PARK ROAD & SAM ALLEN ROAD PD&E

ALTERNATIVE STORMWATER MANAGEMENT FACILITY REPORT

Park Rd./Sam Allen Rd. PD&E Study
WPI Seg No. 257862-1
Draft Pond Siting Report
Response to Comments
October 27, 2004

Response to Comments from Kirk Bogen, FDOT

Figure 5

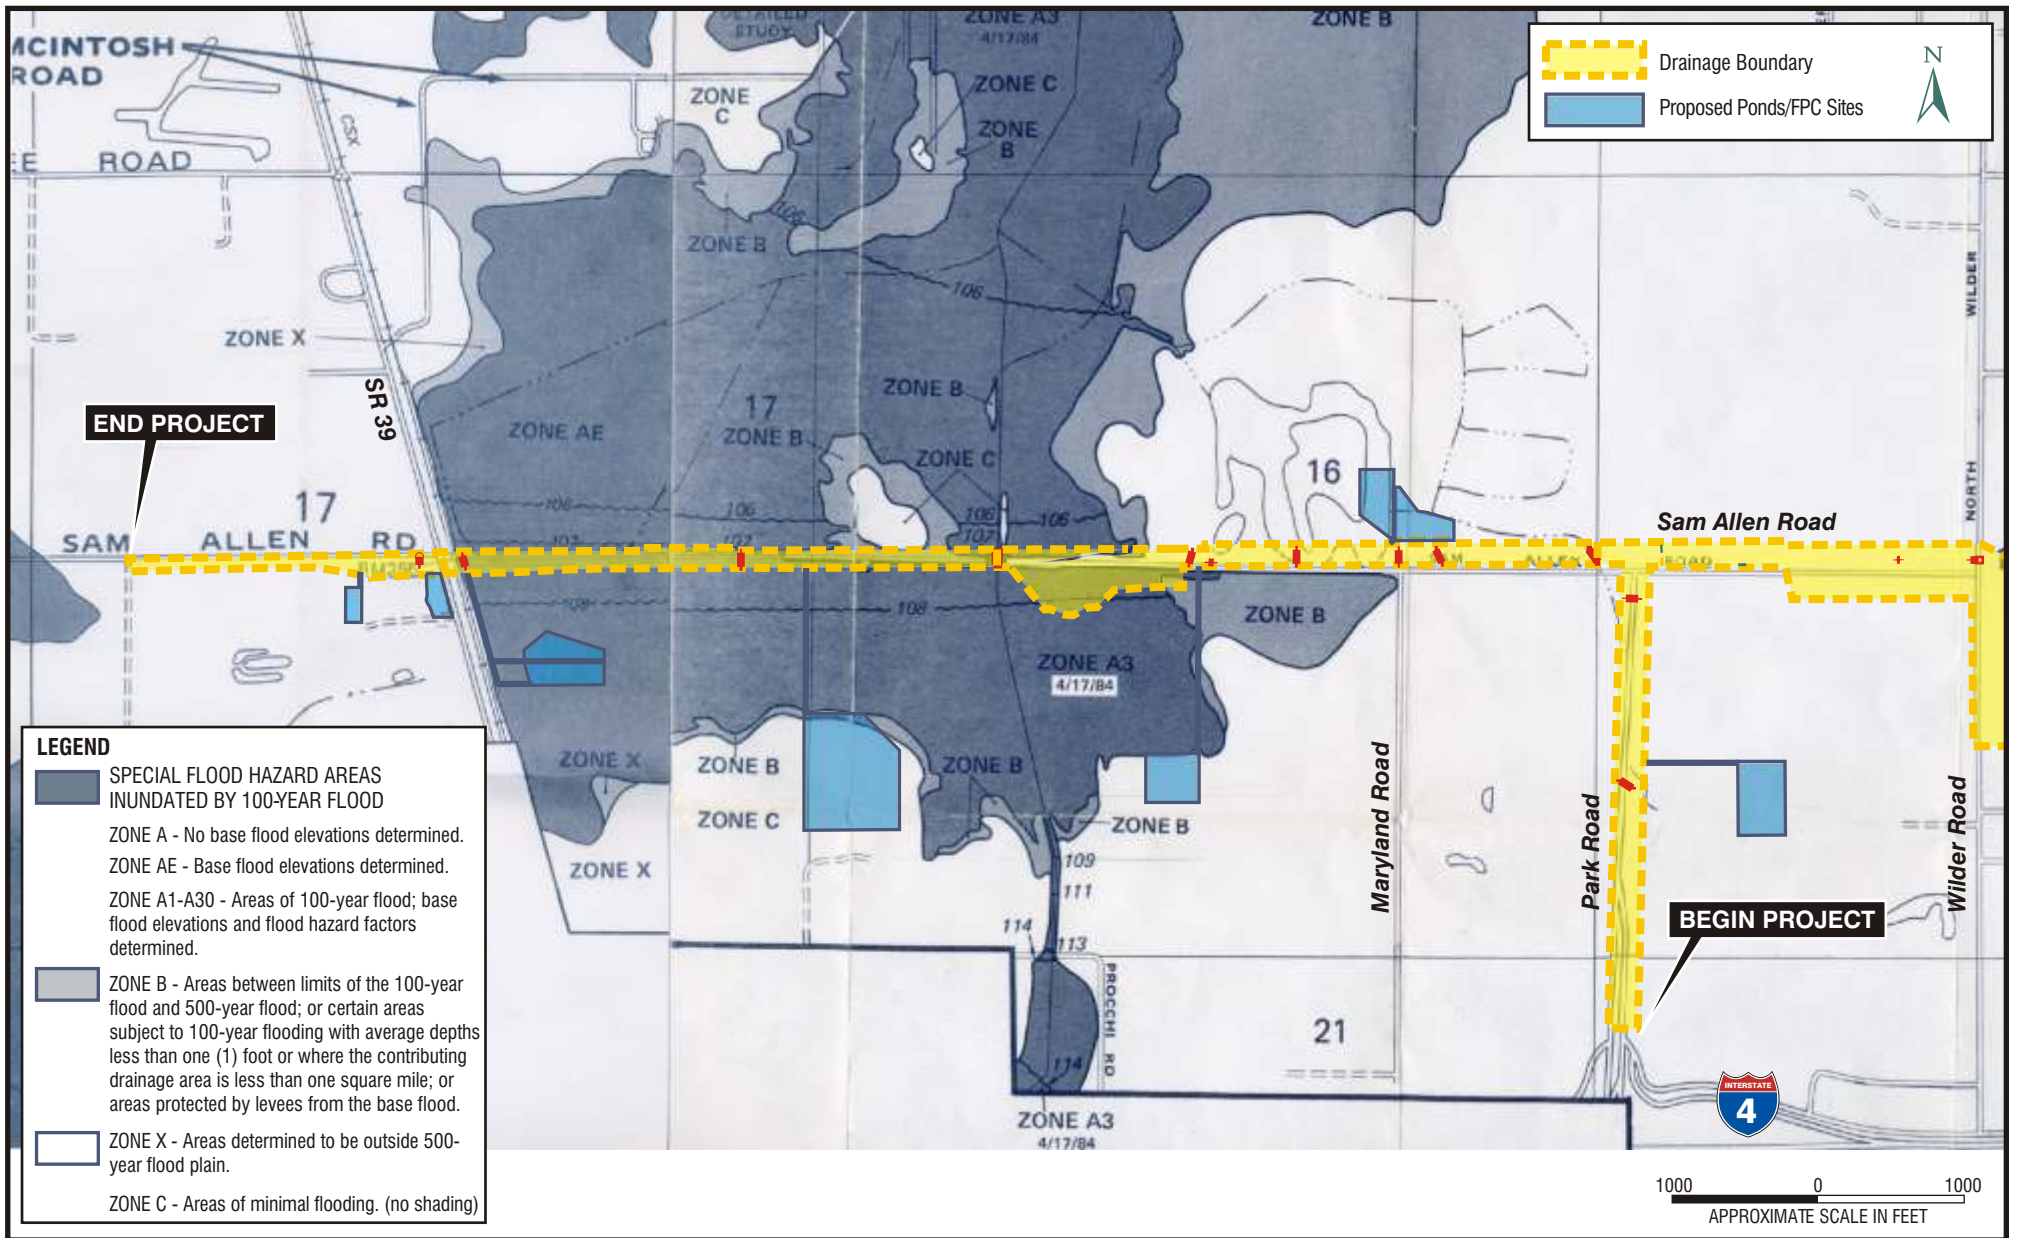
5. Floodplain impacts have been based only on floodplains mapped by FEMA. Verify that the SWFWMD reviewer will accept this definition of floodplains. Most reviewers require mitigation for all floodplain impacts. Note that FEMA doesn't map small floodplains and SWFWMD rules do not differentiate between FEMA floodplains and other floodplains.

5. Floodplain impacts have been based only on floodplains mapped by FEMA. Verify that the SWFWMD reviewer will accept this definition of floodplains. Most reviewers require mitigation for all floodplain impacts. Note that FEMA doesn't map small floodplains and SFWMD rules do not differential between FEMA floodplains and other floodplains.

Response: In addition to the floodplains mapped by FEMA, Hillsborough County has developed a SWMM model of the Hillsborough River watershed. According to this model, the 100-year floodplain elevation is lower than the FEMA elevation. For the purpose of the pond siting report, the FEMA elevations were used to calculate a more conservative floodplain impact. However, floodplain compensation areas will more than likely be reduced during the design phase.

Figure 6

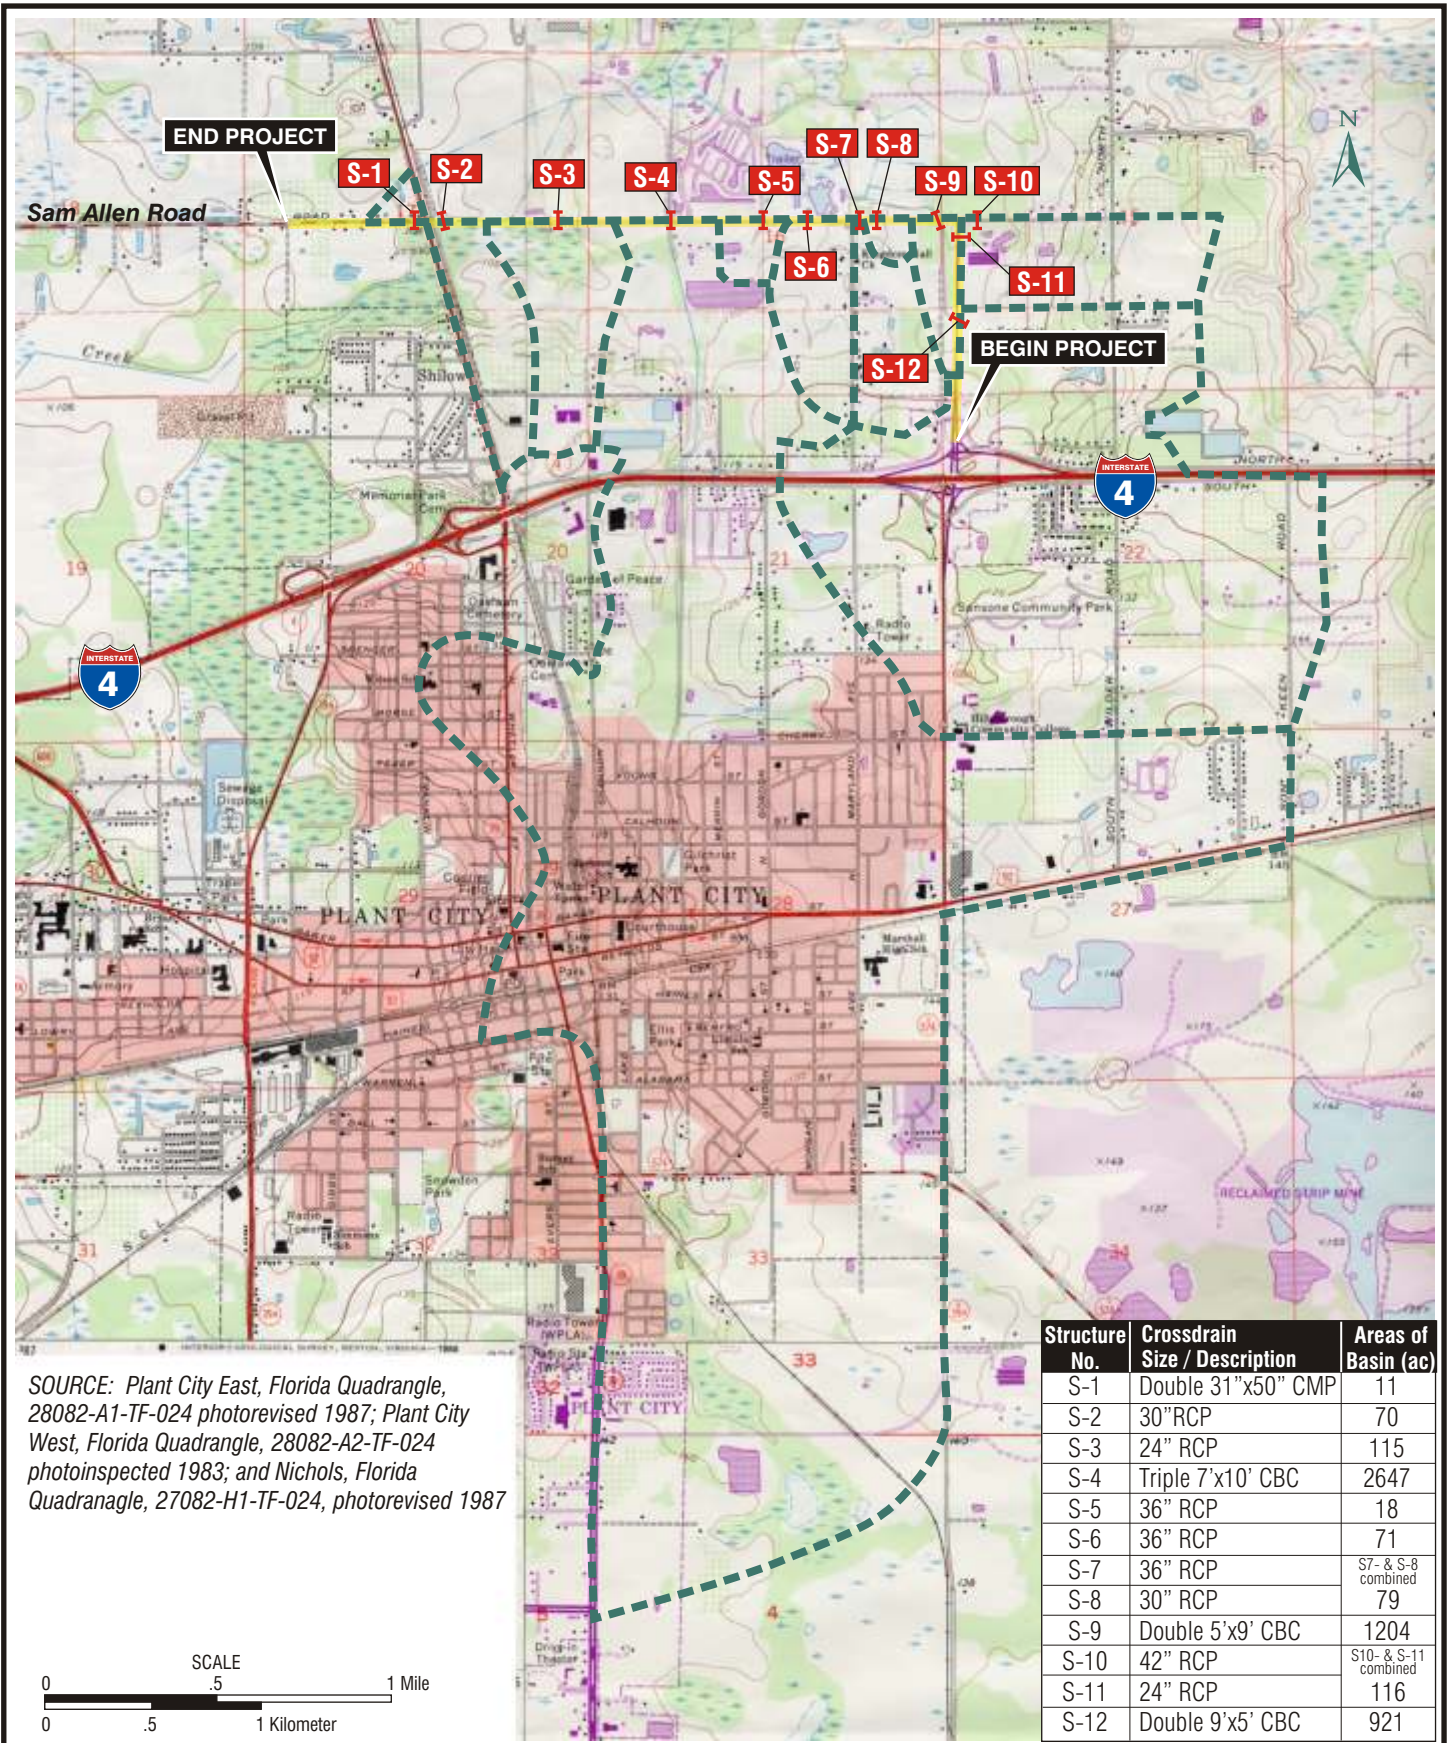
12. Were Figure 6 basin limits obtained from FDOT drainage map? If not, the source should be provided. Some appear incorrect because the pipe sizes don't relate to the basin areas. At flood conditions, some basins probably combine.

12. Were Figure 6 basin limits obtained from FDOT drainage map? If not, the source should be provided. Some appear incorrect because the pipe sizes don't relate to the basin areas. At flood conditions, some basins probably combine.

Response: Basin limits for Figure 6 were developed using the contours of the USGS maps. Reference was also made to the Bill Heard Chevrolet (I-4 at Park Road) SWFWMD permit and the FDOT drainage map for I-4 (Segment 4). This drainage map information will be included in the appendix of the report.
